Addendum

Final Environmental Impact Report

Los Angeles International Airport (LAX)

LAX Sign District Project

1961 ATCT ELEVATION - NORTH

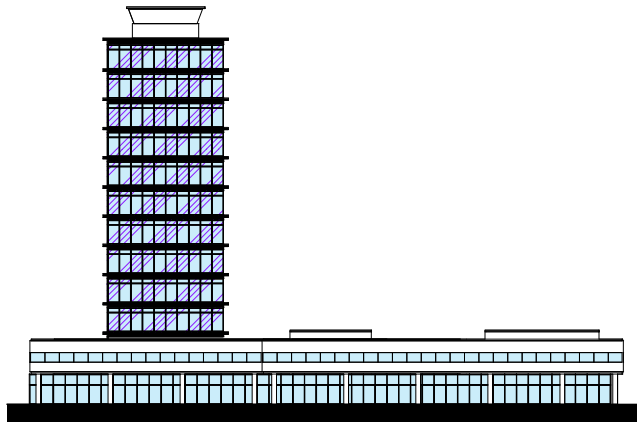
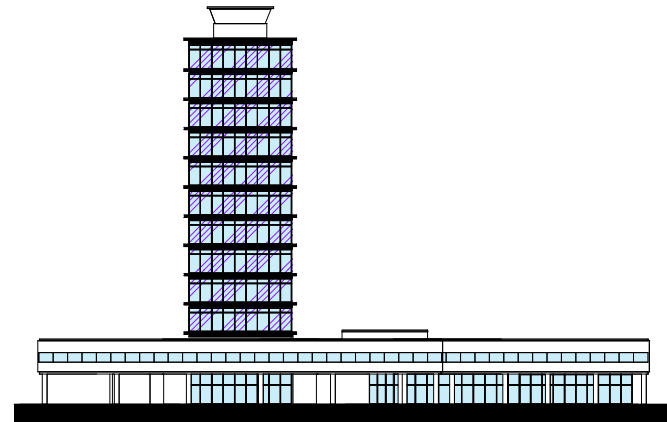
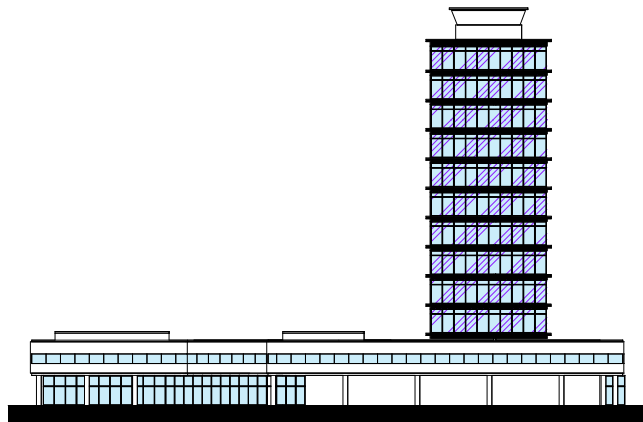
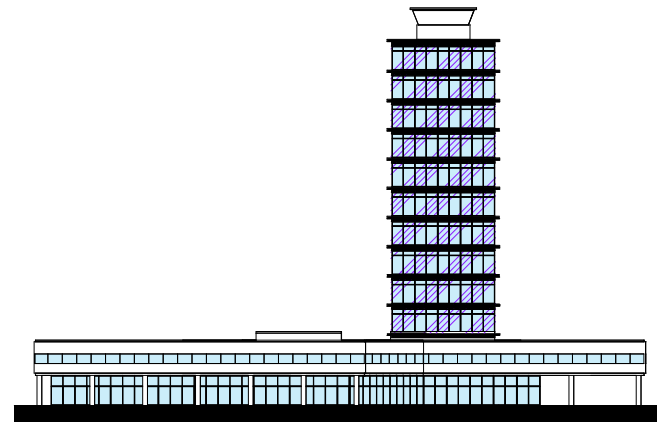
A key element of the Proposed LAX Sign District Project Modifications is the placement of artwork and signage on the 1961 ATCT to display welcome messages and imagery; LAX-related travel and tourism messaging; content celebrating commemorations, City-hosted events, and special occasions; and artistic displays. The 1961 ATCT was part of the original design for the CTA and served as the control tower for LAX until 1996, when it was replaced with a new ATCT. After this replacement, the 1961 ATCT building was used by LAWA for administrative offices. In recent years, use of the 1961 ATCT for offices was discontinued based on concerns about seismic and fire life safety. The 1961 ATCT does not meet modern seismic, life safety, accessibility, and building systems requirements for routine administrative use. Retrofitting the slender, small-floor-plate tower to current codes and workplace standards would require disproportionate structural and system upgrades, making continued occupancy impractical at this time. LAWA proposes to repurpose the building to support a new vision for the LAX gateway. With implementation of the Proposed LAX Sign District Project Modifications, digital displays would be added to all four sides of the tower façades. The digital displays would serve as a landmark and a welcome for airport users and visitors.

In 2016, Historic Resources Group determined the 1961 ATCT to be eligible for listing as a City of Los Angeles Historic-Cultural Monument (HCM).²⁵ As further addressed in the Historical Resources Evaluation Report for the Proposed LAX Sign District Project Modifications (**Attachment 5** of this Addendum), the placement of digital signage on the 1961 ATCT has the potential to adversely affect the historic significance of the 1961 ATCT by altering the building's profile and removing or obscuring its character-defining features. Consistent with LAWA's previous commitment as part of the LAX Preservation Plan and to ensure the 1961 ATCT retains its eligibility as a City of Los Angeles Historic-Cultural Monument, LAWA has developed design strategies to ensure that the proposed installation of signage on the tower would comply with rehabilitation standards established by the U.S. Secretary of the Interior's Standards for Historic Resources.²⁶

LAWA would remove the existing non-contributing exterior guardrails while retaining the original outriggers that the guardrails are attached to. Removal would be completed prior to installation of new signage components and would avoid any disturbance or damage to the historic fabric. If a replacement is deemed necessary to comply with safety codes, it would be designed such that its visual profile is minimal and does not add to or interfere with the overall form and massing of the tower. Any replacement solution must also be such that if removed in the future, the essential form and integrity of the historic resource would be unimpaired, consistent with the Secretary of the Interior's Standards for Rehabilitation.

LAWA would require that any LED digital media display mounted to the exterior of the 1961 ATCT employ permeable technology that allows visibility of the building's original form and surviving features behind the added digital media display.

Conceptual Bands of Digital Media Display

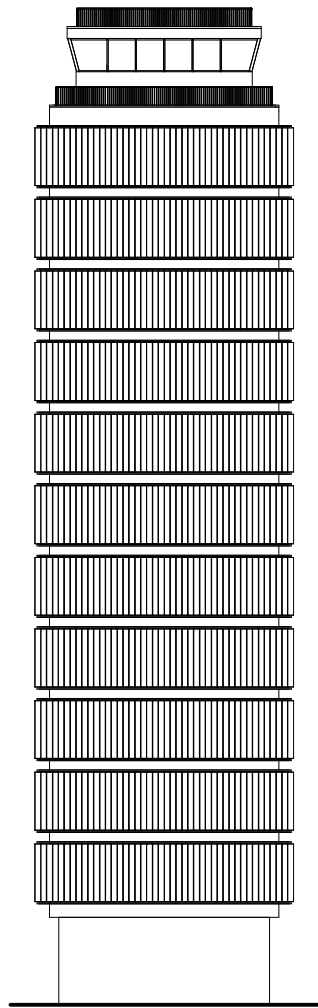
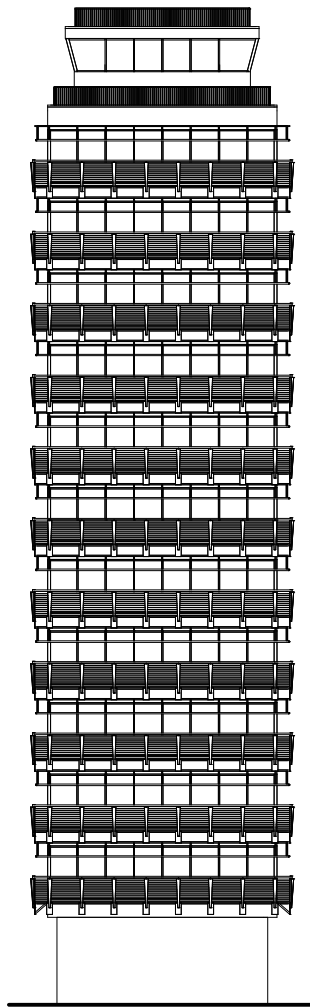
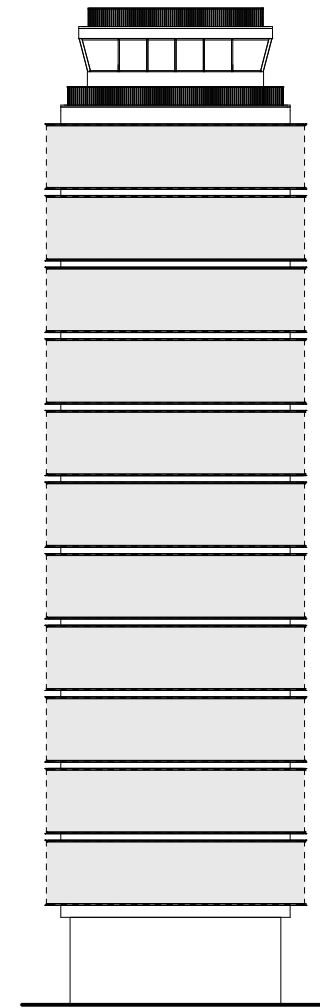
Original Bands of Vertical Louvers

1980s Balcony Guardrail Addition
